Project 59 - 61 Leighton Road  
London  
NW5 2QH

Title BASEMENT PLAN  
(NMA01)

Scale 1:50@A1:1:100@A3	Drawn by VP
Date FEBRUARY 2016	Checked VP
Drawing Number 5381/P/01 NMA 01	Revision -

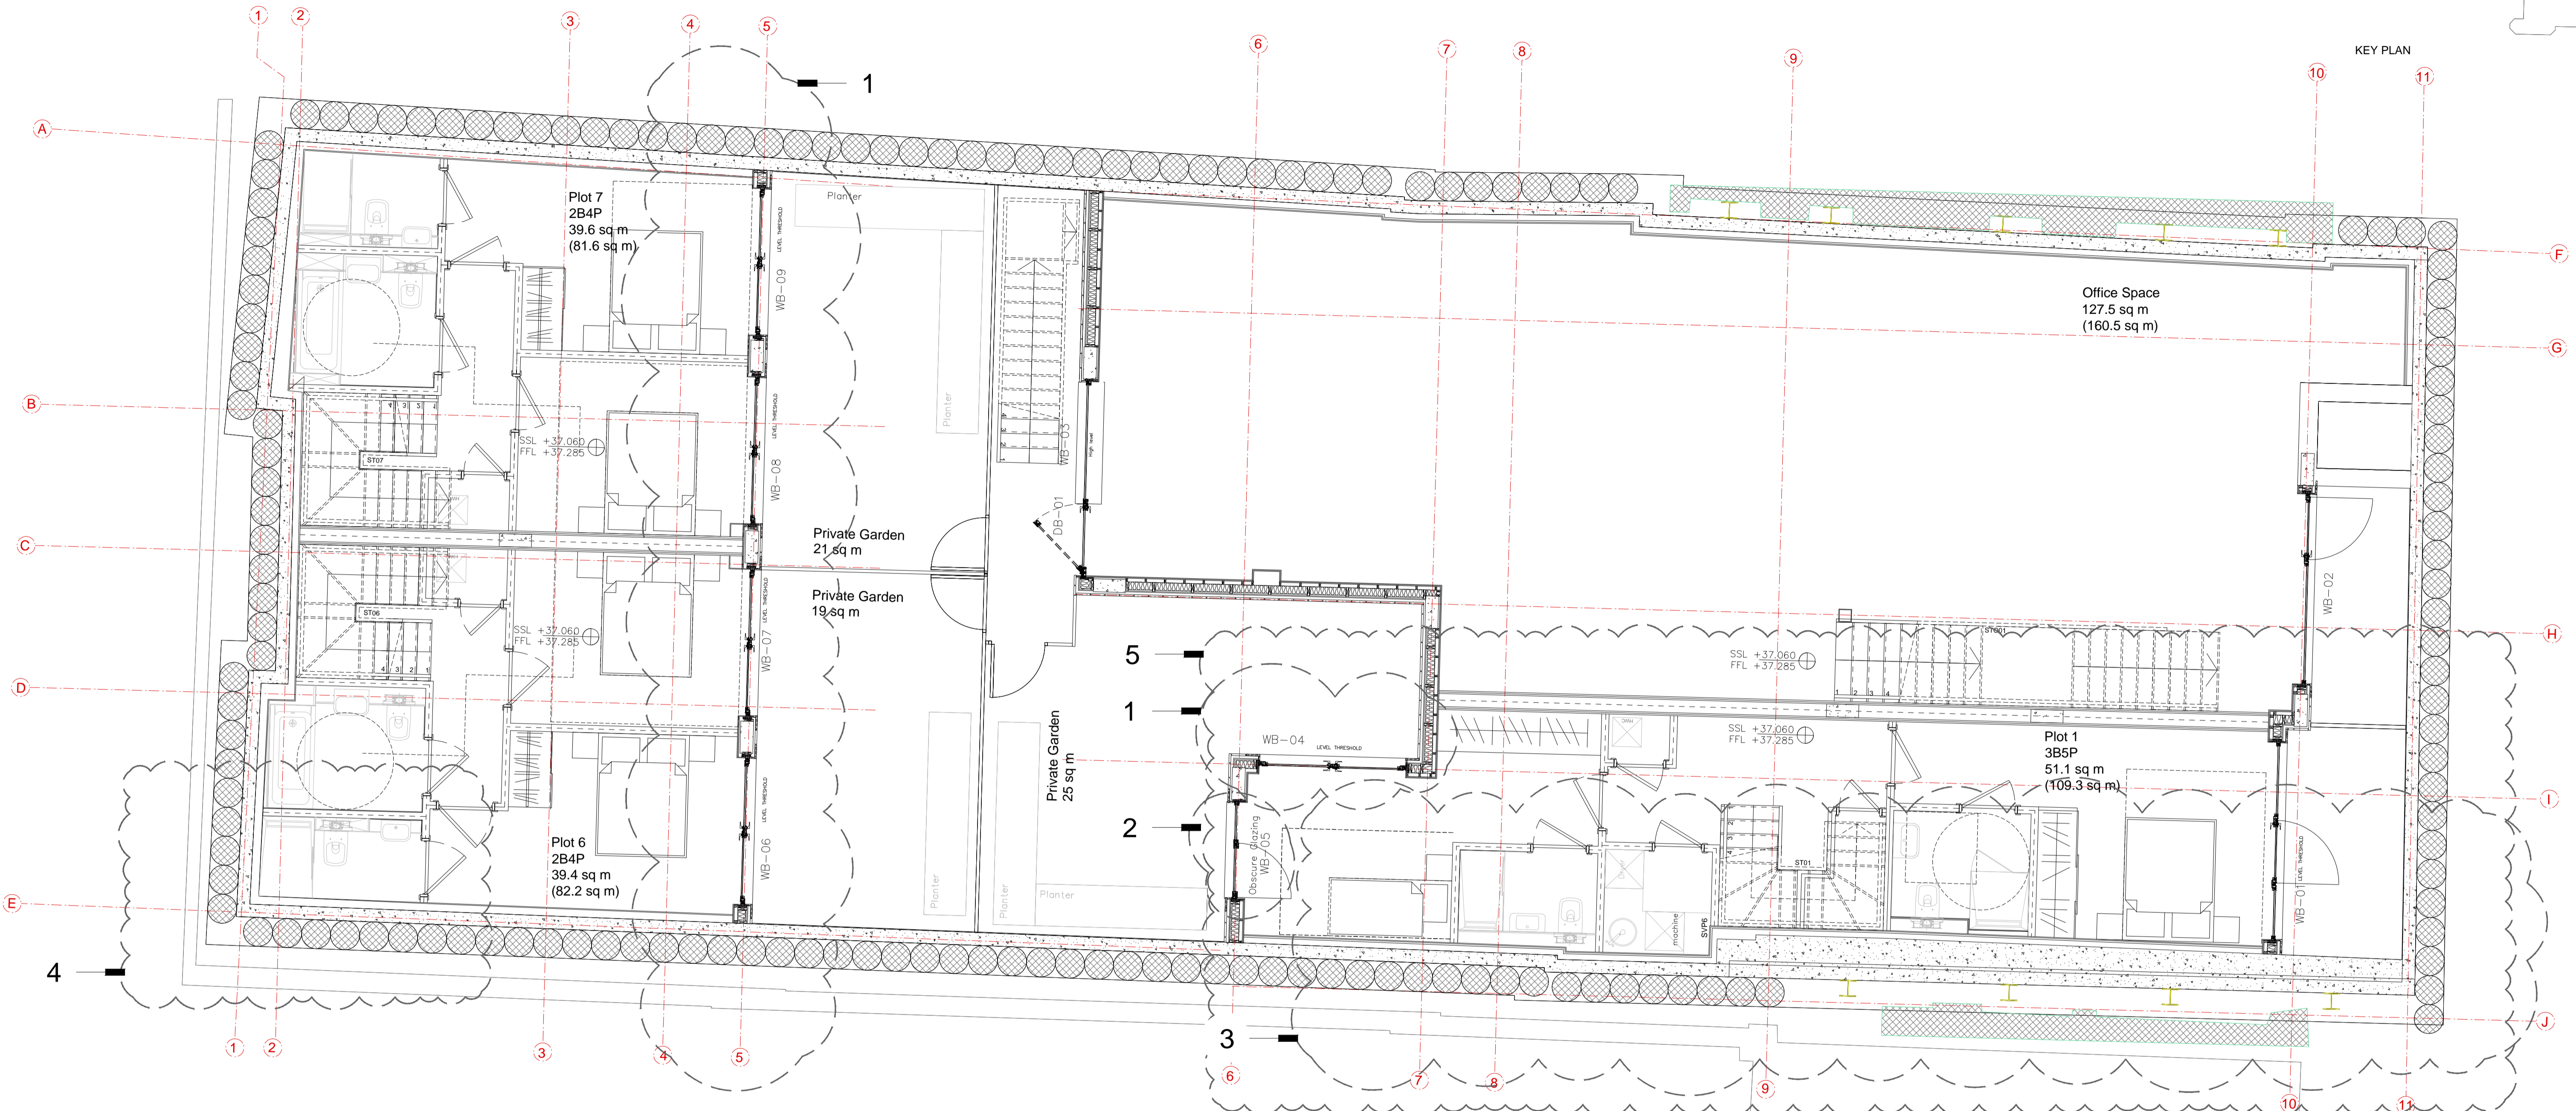
- 1 Sliding doors replaced with openable inwards French doors. Amendment is to achieve better door u values.
- 2 Window size increased. Glazing to be obscured.
- 3 Layout adjustment following retaining wall review.
- 4 En Suite added.
- 5 Plot1 description 3B5P amended from 6P. Layout adjusted to comply with LTH
